Wiston Estate

Rampion 2 Cable Route Alternatives & Mineral Sterilisation

4 June, 2024

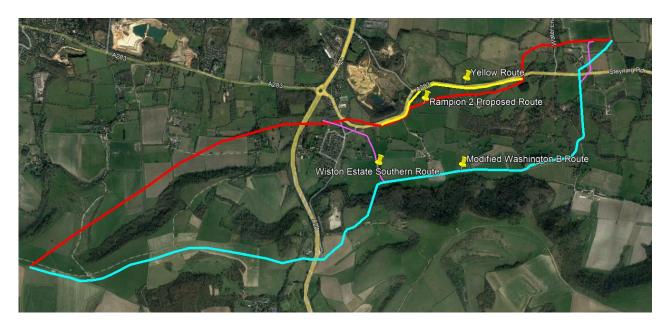
A considerable length of the Onshore Cable Route for the Proposed Development passes through the Wiston Estate ('the Estate') and our high level assessment concludes the route is likely to sterilise approximately **7 million tonnes** of soft sand mineral, as well as significantly impact ongoing and future operations for the Estate and its tenants. For the avoidance of doubt, the approximate route of the proposed cable route in this area is shown below by the red line.

The modified Washington B Route alternative, shown in blue below, would reduce the amount of mineral sterilisation from approximately 7 million tonnes to 600,000 tonnes, a reduction of 6.4 million tonnes.

The Wiston Estate Southern Route alternative, shown in pink below, would reduce the amount of mineral sterilisation from approximately 7 million tonnes to 600,000 tonnes, a reduction of 6.4 million tonnes.

The Yellow Route alternative, shown below in yellow, would reduce the amount of mineral sterilisation from approximately 7 million tonnes to 2.5 million tonnes, a reduction of 4.5 million tonnes.

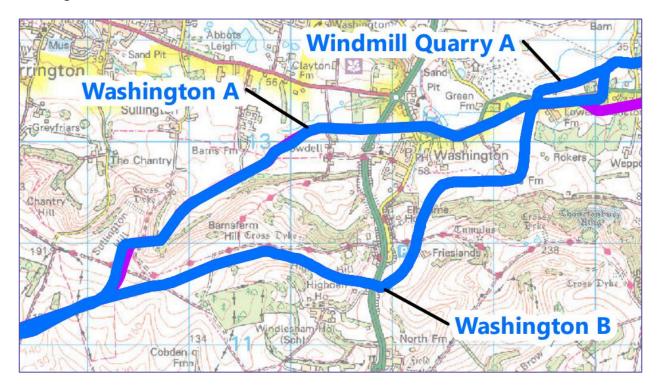
Summary of mineral sterilisation as a result of the Applicant's proposed Onshore Cable Route

Area	Sterilised Minerals (tonnes)
1) Land south-west of Rock Common Quarry	400,000
2a) Western area of Lower Chancton farm	3,000,000
2b) Eastern area of Lower Chancton farm	1,800,000
3) Land north of the A283 Road forming part of Upper Chancton Farm	1,800,000
Total	7,000,000

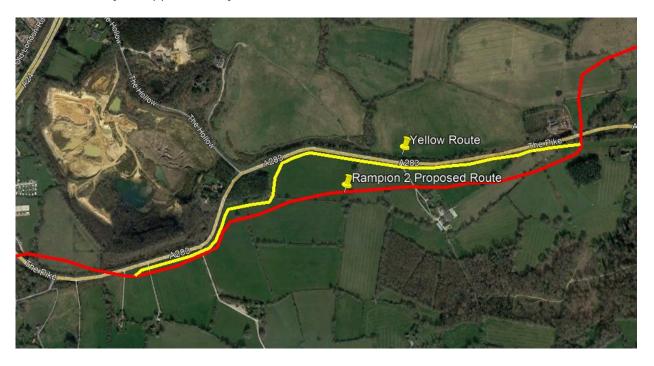
We have assessed an alternative cable route which would involve 'HDDing' to the area located between the entrance to Tilley's Farm and Walnut Tree Cottage; this area is located outside of the Applicant's Order Limits, approximately 80m south of land parcel 22/17. From this point the cables would head south for approximately 500m before picking up the same route as proposed for the Modified Washington B Alternative Route. This route, referred to as the Wiston Estate Southern Route, is shown below by the pink line.

To ensure the required HDD orientation can be achieved to avoid the minerals north of the A283 (i.e. south of Rock Common Quarry), it may be necessary for the Applicant to drill to or from the recreational fields north of Washington (i.e. the north-eastern corner of plot 22/7). We do not see any reason why this is not technically feasible as the HDD length would be less than 500m. It is worth noting the recreational fields are classified as special category land, hence there is a risk the Applicant would need special parliamentary procedure to secure the rights required for the Proposed Development in this area. Notwithstanding this, the alternative proposed would minimise sterilisation of the minerals south of Rock Common Quarry and would be likely to reduce the sterilisation of minerals at the estate by approximately **6.4 million tonnes** compared to the Applicant's proposed route.

8. The Sawyers Copse Pinch Point

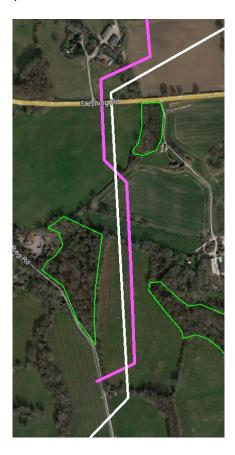
In relation to the Modified Washington B Alternative Route and the Wiston Estate Southern Route, we understand the Applicant has discounted the ability to run the cables through the two respective areas of Sawyers Copse (categorised as Ancient Woodland) because of spatial constraints. We are aware the gas pipeline already runs in a north to south direction between the two areas of Sawyers Copse.

Sawyers Copse - Option 1

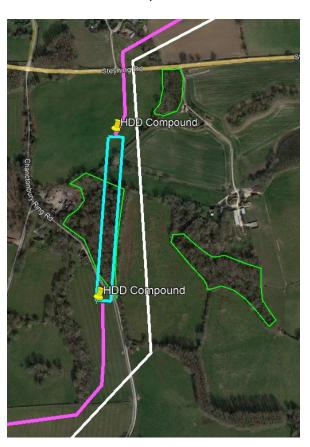
If the applicant were to cross the gas pipeline with the cables and run them in a north south direction to the east of the gas pipeline, there is a corridor available for installation. With regards to buffer zone recommendations the UK's Government Guidance 'Ancient woodland, ancient trees and veteran trees: advice for making planning decisions' states 'For ancient woodlands, the proposal should have a buffer zone of at least 15 metres from the boundary of the woodland to avoid root damage (known as the root protection area). We are also aware of the protective provisions in relation to the pipeline

apply from the point at which works are taking place within 15m of the gas assets. Applying the advised buffer to the Ancient Woodland and the gas pipeline leaves a corridor of 30m within which to install the cables. Whilst this is narrower than the 40m construction corridor, based on our knowledge and experience, it will still be possible to install the cables in this area by making minor modifications to the installation process. This route is shown by the pink line below. The approximate location of the gas pipeline is shown in white and the approximate outline of the ancient woodland is shown in green in the aerial view titled 'Sawyers Copse – Option 1' below.

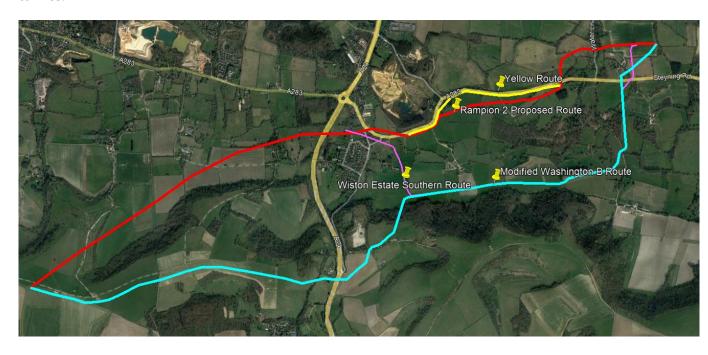
For the avoidance of doubt, the Applicant's proposed cable route is shown in red below.

The modified Washington B alternative, shown in blue below, is likely to reduce the amount of mineral sterilisation from approximately 7 million tonnes to 600,000 tonnes, a reduction of 6.4 million tonnes.

The Wiston Estate Southern alternative, shown in blue below, is likely to reduce the amount of mineral sterilisation from approximately 7 million tonnes to 600,000 tonnes, a reduction of 6.4 million tonnes.

The Yellow Route alternative, shown in yellow below, is likely to reduce the amount of mineral sterilisation from approximately 7 million tonnes to 2.5 million tonnes, a reduction of 4.5 million tonnes.
